GLENORCHY PLANNING AUTHORITY MEETING

5. PROPOSED USE AND DEVELOPMENT - NEW BUILDING FOR SPORT AND RECREATION - 61 CLAREMONT LINK ROAD CLAREMONT

Application No:	PLN-25-078
Applicant:	All Urban Planning
Owner:	Department of Education and Young People
Zone:	Community Purpose Zone
Use Class:	Community Meeting and Entertainment
Application Status:	Discretionary
Discretions:	27.4.1 Non Residential Use, 27.4.1 Building height, C1.6.1 Design and siting of signs, C1.6.2 Illuminated signs, C2.6.5 Pedestrian access, C3.5.1 Traffic generation at a vehicle crossing, level crossing or new junction, and C12.6.1 Buildings and works within a flood-prone hazard area.
Level 2 Activity?	No
42 Days Expires:	16 July 2025

Figure 1 General flood hazard vulnerability curves

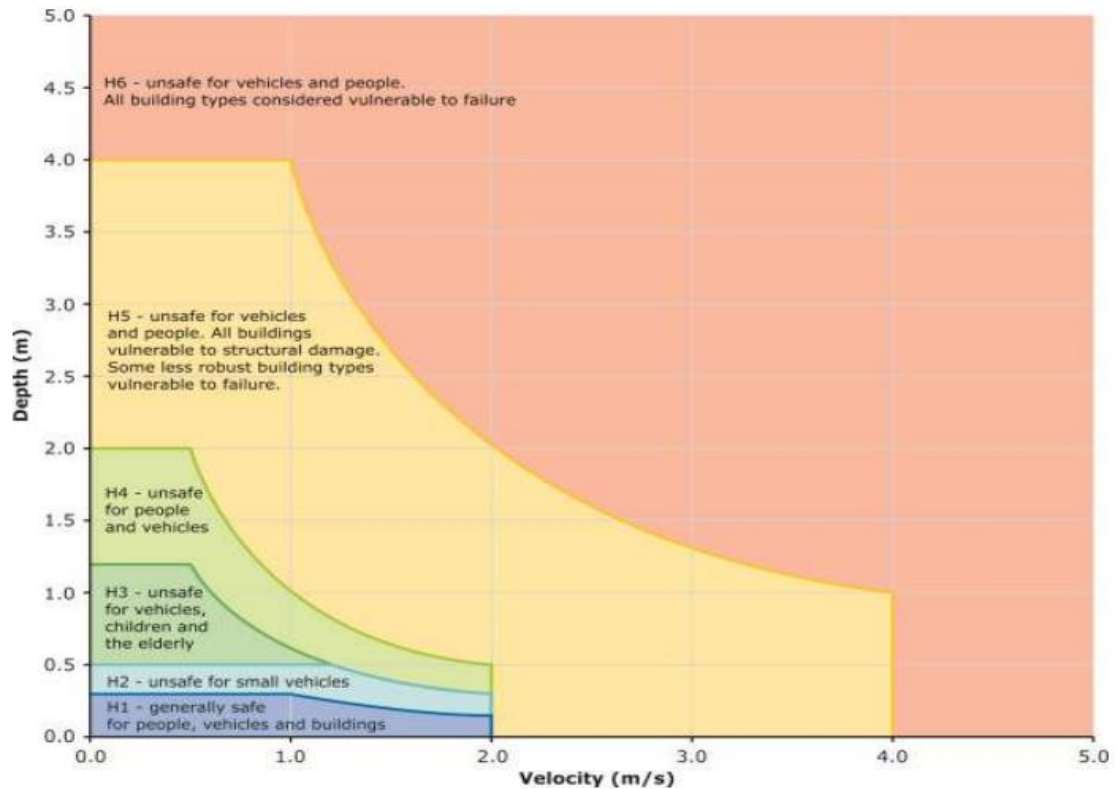
Flood hazard is generally categorised based on the combined impacts of expected flood depths and velocities as per Australian Disaster and Resilient Handbook. Below graphical representation indicates the 6 categories from H1 to H6.

Figure 2 Pre-development Flood Hazard Extents

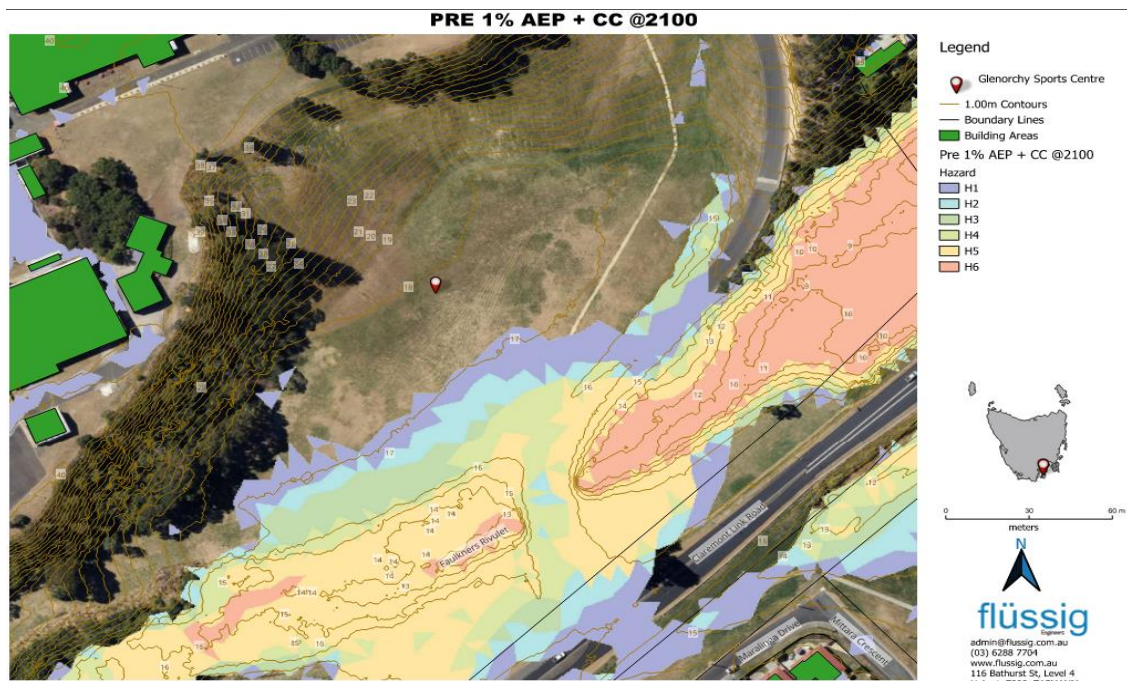
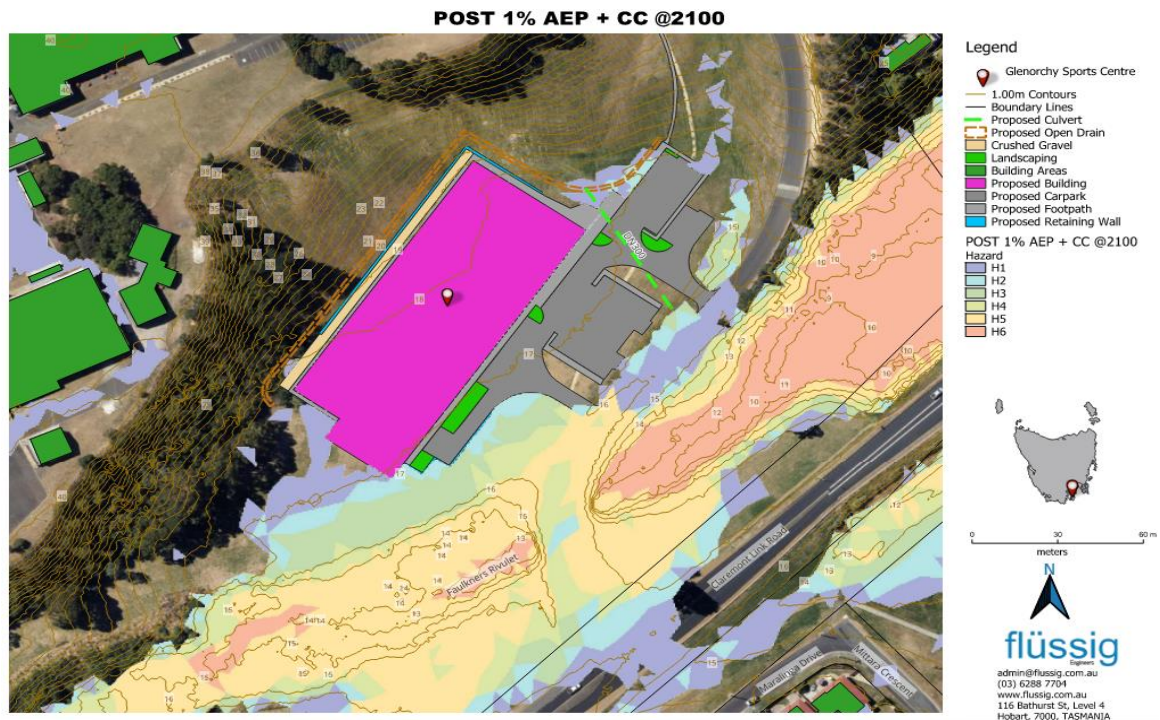
Flussig report has identified that the proposed developed of the multi-sport centre at 61 Claremont Link Road is susceptible to a fast moving and deep flood flow, with the surrounding region classified in the range H1-H6 hazard rating in the 1 % AEP + climate change event. This means some areas of the site are considered generally unsafe for people and vehicles.

Therefore, Flussig report has provided a range of recommendations including:

- Raising the finished floor levels higher than the 1% AEP flood in accordance with Building regulations;
- Adoption and maintenance of flood management plans to all on-site facility users;
- No additional solid structures be constructed around the property without further flood assessment;
- Construct a new cutoff drain along the western side of the proposed facility, positioned at the top of the proposed retaining wall;
- Install a new DN300 pipe and associated pits to facilitate dewatering of the northern corner of the facility area, or implement any other structures that can achieve similar results; and
- Landscaping around the driveways and carpark areas should consist of stabilised, non-erosive materials.

The Flussig report suggests that the proposed sports facility and associated infrastructure do not displace overland flow onto neighbouring properties. The design effectively addresses potential flood-related risks within the site, supporting its long-term resilience and functionality. The development's infrastructure effectively directs and controls runoff, reducing potential risks associated with increased surface water accumulation and ensuring compliance with local flood management guidelines.

In summary, I have no objections with the proposal from a hydraulics perspective [subject to conditions].
